REGULAR MEETING OF THIRD LAGUNA HILLS MUTUAL ARCHITECTURAL CONTROL AND STANDARDS COMMITTEE*

**Monday, January 08, 2024 – 1:30 p.m.
Laguna Woods Village Board Room/Virtual Meeting
24351 El Toro Road, Laguna Woods, California**

DATE: January 8, 2024
FOR: Architectural Control and Standards Committee
SUBJECT: Elimination of Low Flow Toilet Statement of Compliance

DATE: January 8, 2024
FOR: Architectural Control and Standards Committee
SUBJECT: Revision to Architectural Standard 8: Porch Lift/Elevators

Revise Alteration Standard Section 21 Patio Slabs

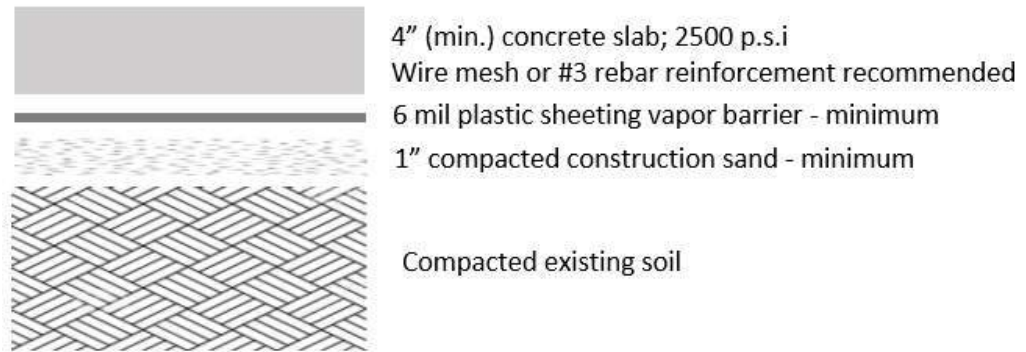
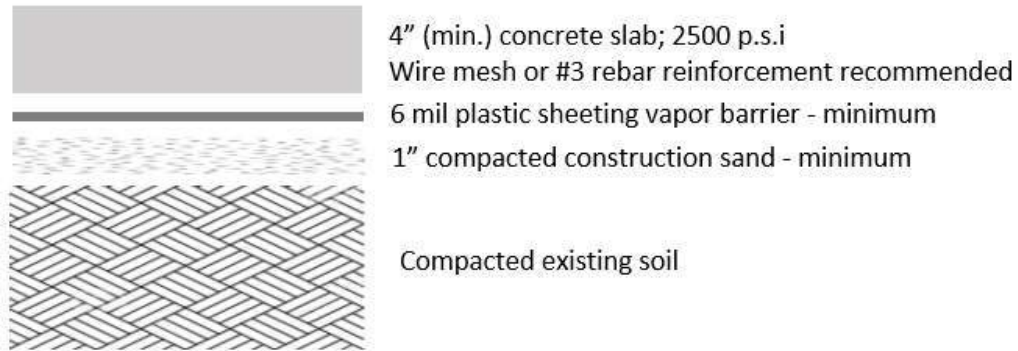
The slab construction methods, materials and the overall size of the patio slabs were also reviewed and taken into consideration. A section detail showing the various layers and components was developed as a means to best clarify the construction process.

- 3.1 Patios & walkways may be constructed of a concrete slab or interlocking concrete pavers. ~~only.~~
- 3.2 Plantings or dirt areas inside the defined patio squared off perimeters ~~walls~~ may be paved over with concrete or interlocking pavers providing the paving does not extend beyond the wall.
- 3.3 Concrete slabs to be constructed as per section detail. will be 4"

3.3 Concrete slabs to be constructed as per section detail.
